Type of Action: Plug and Abandonment

**DJR Operating, LLC
Plug and Abandonment Procedure
Jicarilla L 160 4
API # 30-039-82238
NW/NW, Unit D, Sec. 15, T23N, R2W
Rio Arriba County, NM**

Attachment to notice of Intention to Abandon

Well: Jicarilla L 4

Proposed Wellbore Diagram
DJR Operating, LLC
Jicarilla L 160 4
API # 30-039-82238
NW/NW, Unit D, Sec 15, T23N, R2W
Rio Arriba County, NM

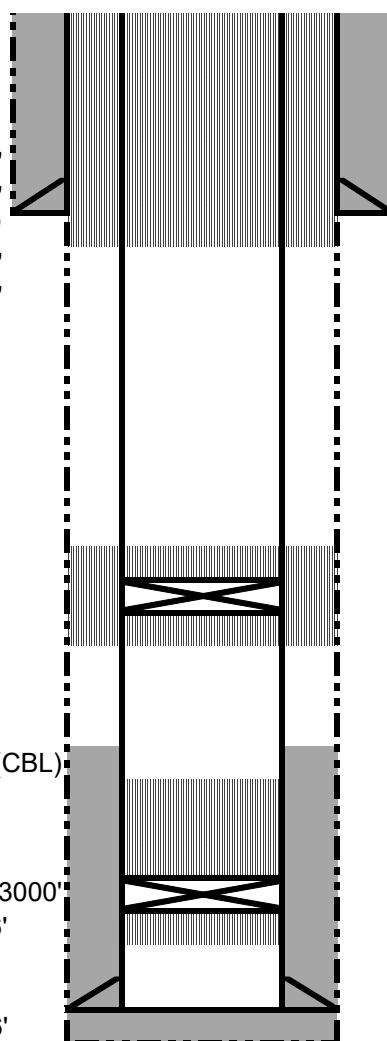
You are also required to place cement excesses per 4.2 and 4.4 of the attached General Requirements.
